NUMBER
038

DATE
November 2007

TECHNICAL SERVICE BULLETIN

2.5L/2.7L (DELTA) ENGINE HESITATION / MIL ILLUMINATION / P0123

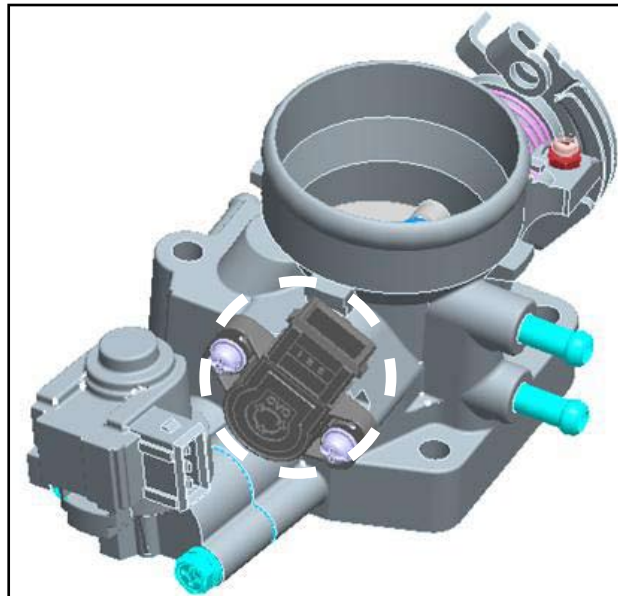
This bulletin provides information relating to an engine hesitation or the illumination of the Malfunction Indicator Lamp (MIL) for P0123 (Throttle Position Sensor / Switch "A" Circuit High Input).

Some 2001-2006 Optima (MS) produced between 10-07-2000 ~ 08-31-2005, equipped with the 2.5L or 2.7L (V-6) Delta Engine and some Sportage (KM) models produced between 10-28-2004 ~ 05/18/2007 equipped with the 2.7L (V-6) Delta Engine are applicable for this bulletin. Improper throttle position sensor values may cause the engine to hesitate under loads or cause the illumination of the MIL. To correct for this condition, the throttle position sensor (TPS) has been improved.

Part Number	
Previous	New
35170 37100	35170-37100FFF
